**PRELIMINARY DRAINAGE DESIGN REPORT
FOR
71ST STREET & EARLL DRIVE
PRELIMINARY DESIGN**

Stormwater Review By:

Review Cycle _____ Date 12/8/15

Battery - 12/8/15 Review

GALLERY
PREVIOUSLY
DEVELOPED AREA

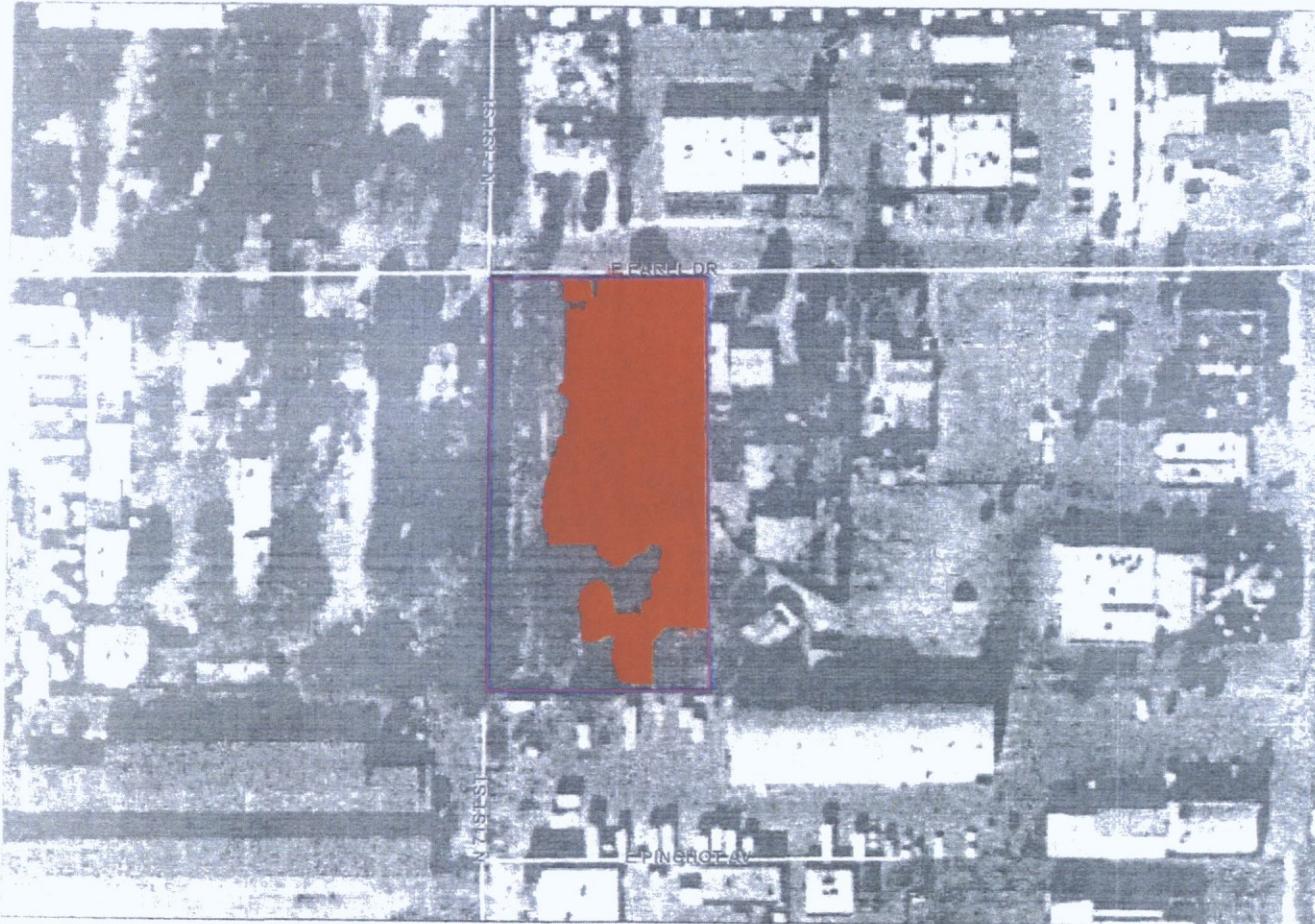
Required volume is

$$V = 2.16/12 (1.07 \text{ ac}) 43,560 (0.94 - 0.67) \\ = 2,265 \text{ ft}^3$$

* entire site previously dev. at B1-7
